Docket Items # 4 & #5 BAR CASE # 2014-0061 & 2014-0062

BAR Meeting April 2, 2014

ISSUE: Permit to Capsulate/Demolish and alterations, and Waiver of

LOCATION: 513 Duke Street

A2

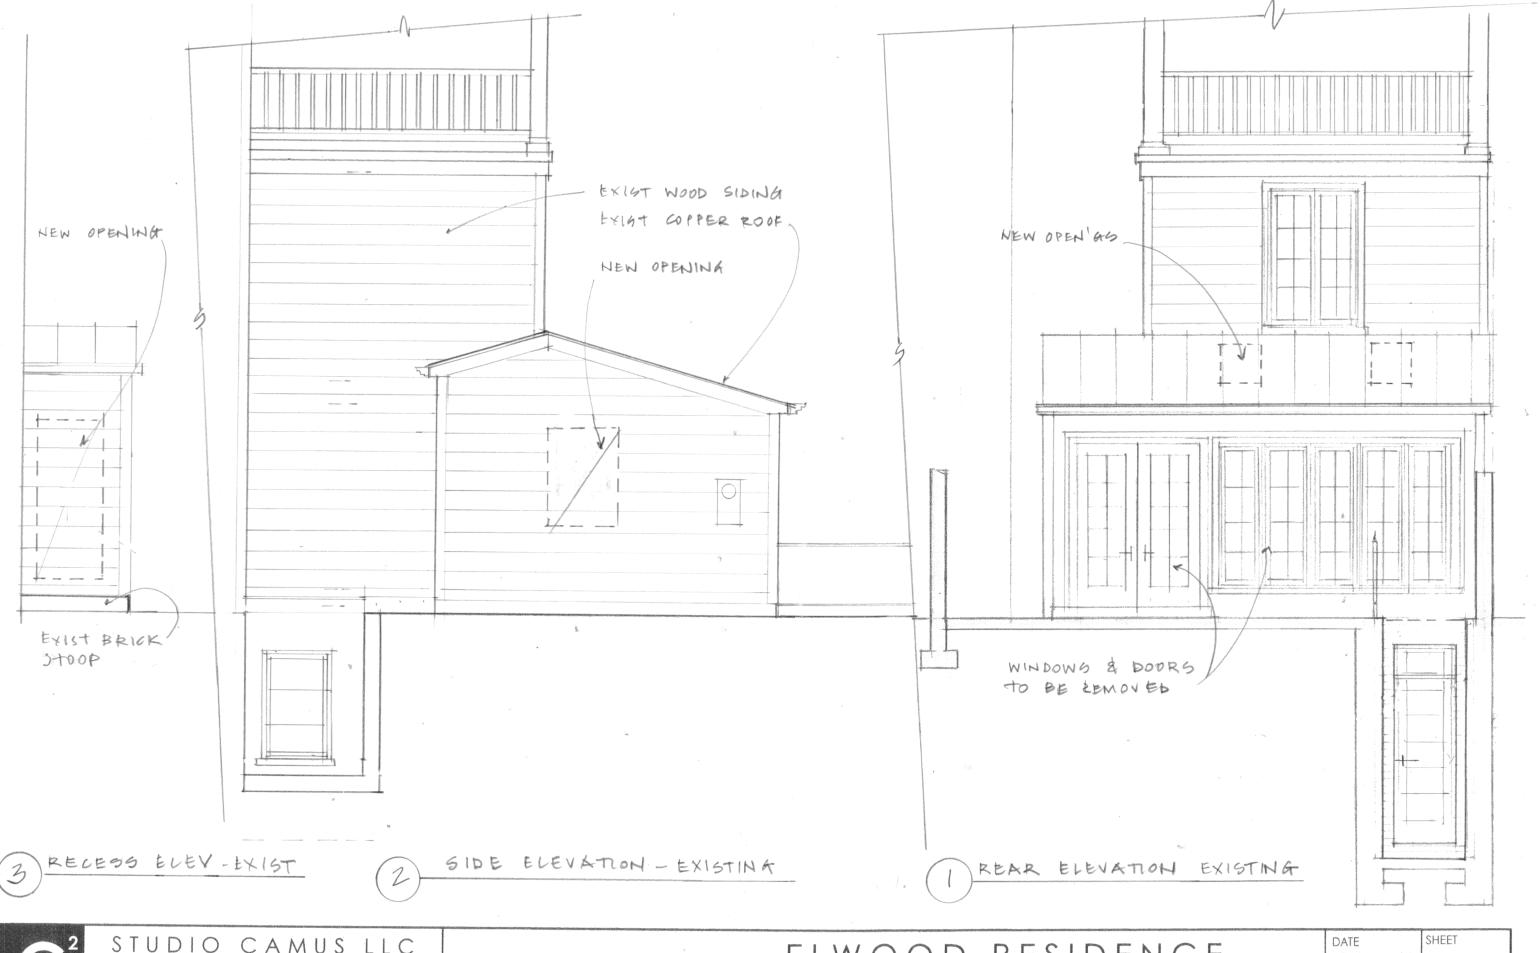
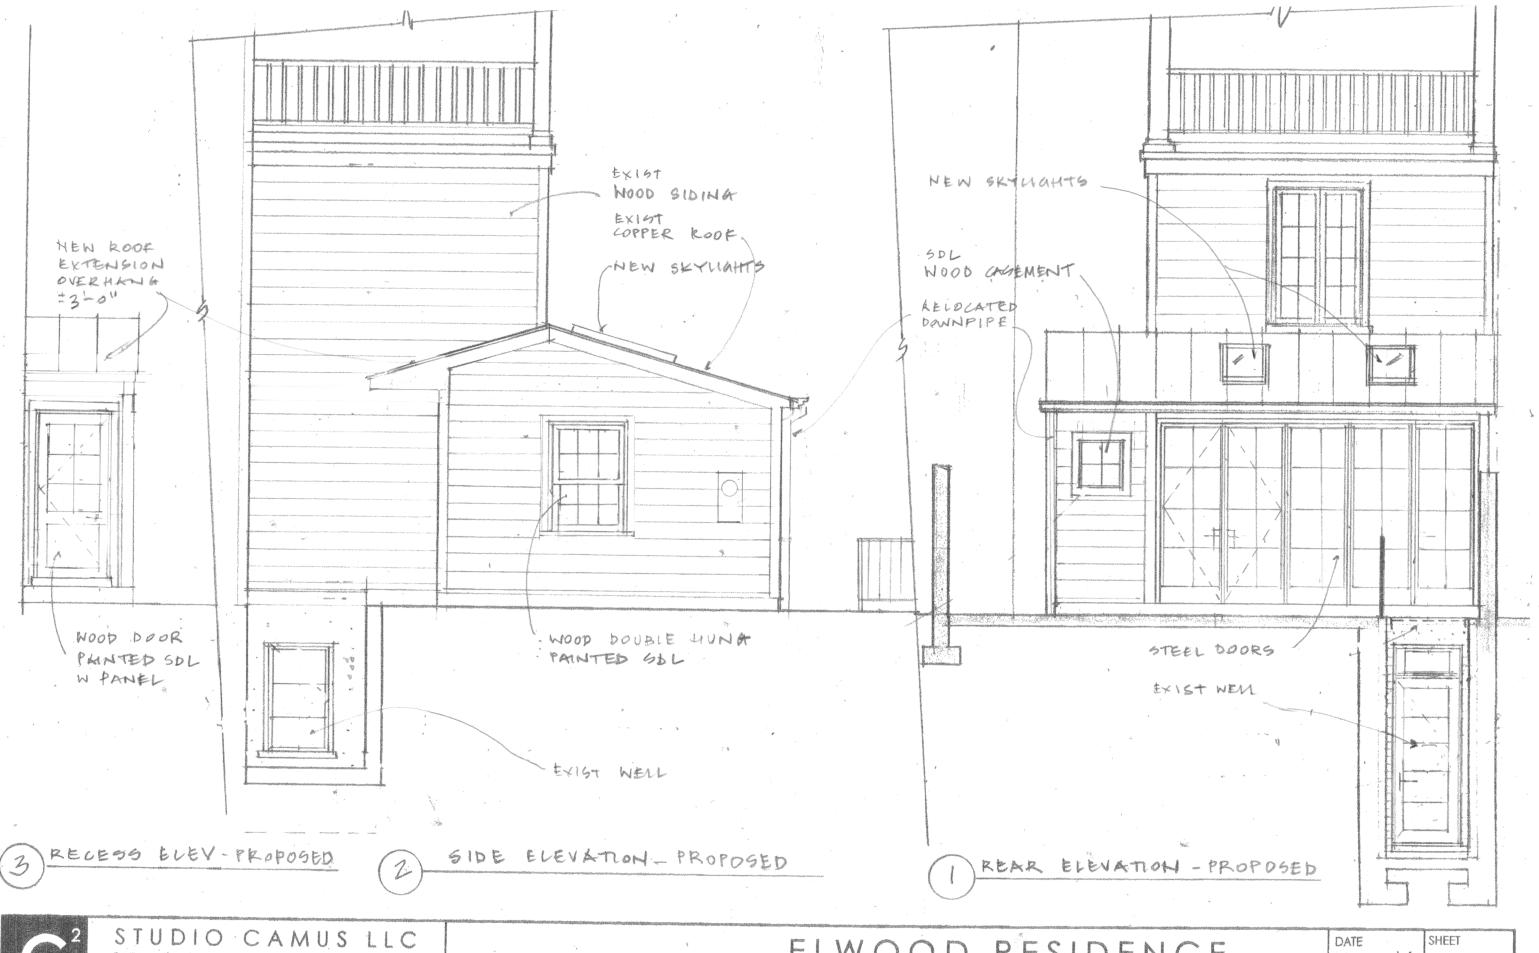
- 1. That the front basement windows be wood, with true-divided-lights in accordance with the Board's Window Policy; and
- 2. That the muntins on the proposed replacement windows have a 5/8 inch putty profile, rather than the proposed 7/8 inch beaded profile, to be more historically appropriate.

However, he Board's Window Policy states: "Singled glazed painted wood sash must be used on the street facades of 18th and 19th century buildings with multi-light windows." While clad and composite windows have occasionally been approved by the Board on early buildings, they were generally on secondary elevations or when the front façade was set back from the sidewalk and screened by landscaping. In this particular instance, Staff does not support the proposed aluminum clad, simulated-divided-light windows on the front façade because they are immediately adjacent to the brick public sidewalk and highly visible. Staff, therefore, recommends that the two basement windows be single-glazed, true-divided-light wood windows. Furthermore, Staff recommends that the beaded muntin profile on all of the proposed replacement windows and doors be replaced with a putty profile, as this the historically appropriate muntin profile recommended by the Window Policy. Nevertheless, staff recognizes the difficulty maintaining modern

wood windows in this location adjacent to grade and the Board may wish to consider a field painted, single glazed fiberglass window in this location, if available.

ALLEY ELEVATION

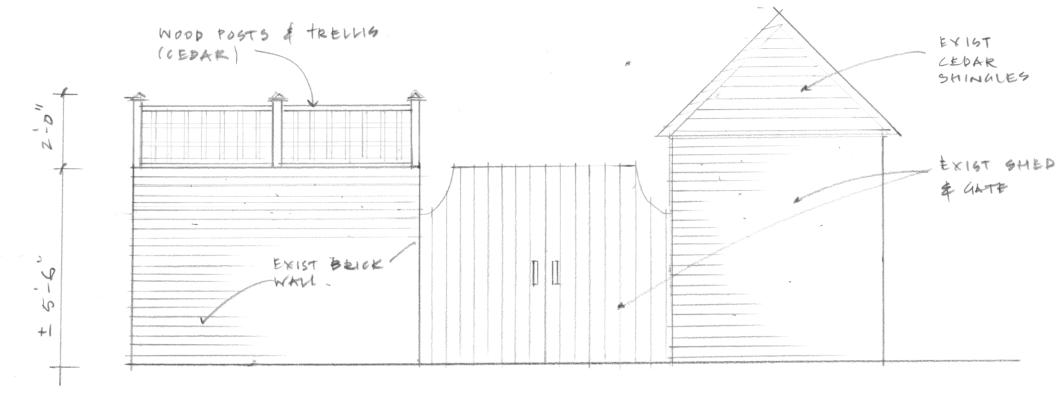
Section 7-202(B)(3) of the zoning ordinance permits fences which do not exceed 6 feet in height in required side and rear yards. However, Section 7-200(C) of the Zoning Ordinance permits the BAR to modify or waive the fence requirements if the Board finds that a proposed fence will be architecturally appropriate and consistent with the character of the district. Staff finds the proposed two foot fence height increase, which will not be visible from the public right-of-way, to be architecturally appropriate.
